### MISCELLANEOUS PROPOSALS OF AMENDMENTS TO THE MODEL REGULATIONS ON THE TRANSPORT OF DANGEROUS GOODS

#### Fumigated cargo transport units and cargo transport units containing dangerous goods for cooling or conditioning

Transmitted by the European Industrial Gases Association

**Appendix A**

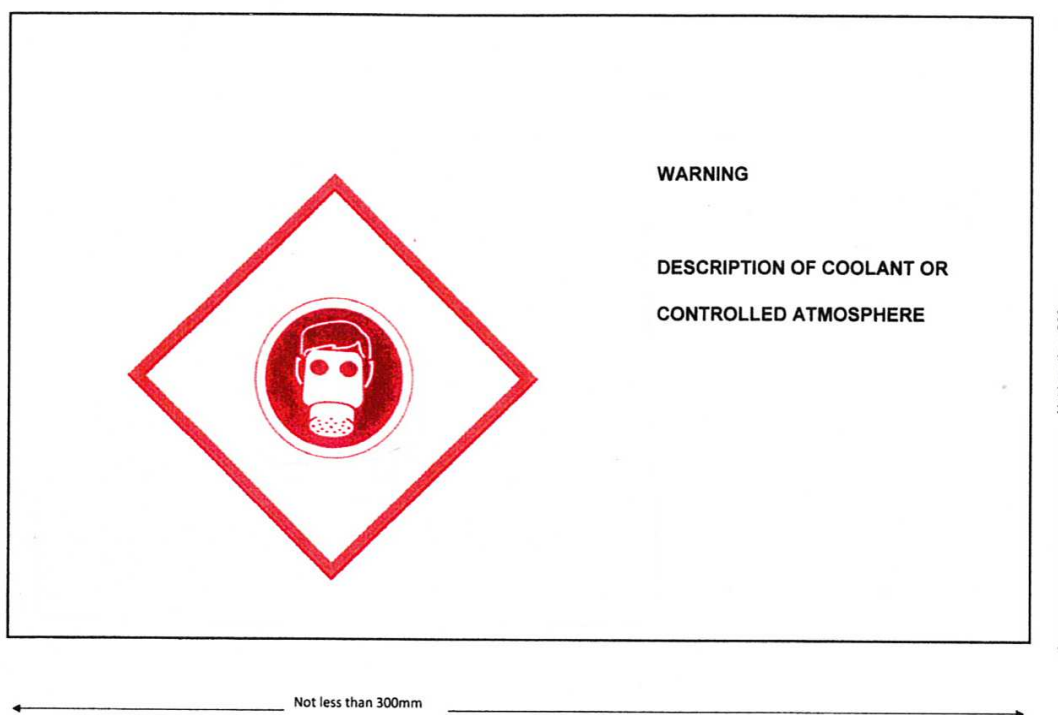
The sign proposed on the placard shows a standard type respirator. These are used where they may be dust or a gas present in air that is harmful to health. This item is only worn where the atmosphere consists of mainly air and not one where there is an oxygen deficiency. The device does not provide any oxygen (or air) to sustain life and a user who is wearing such a device and enters an atmosphere where there is oxygen deficiency will at best lose consciousness.

EIGA is concerned that a user who sees such a sign on a placard with a respirator on it may consider such a device will support life in an oxygen deficient atmosphere and then enter the area.

The proposal is to replace the sign on the placard in Appendix A with either of the signs shown in Appendix B.
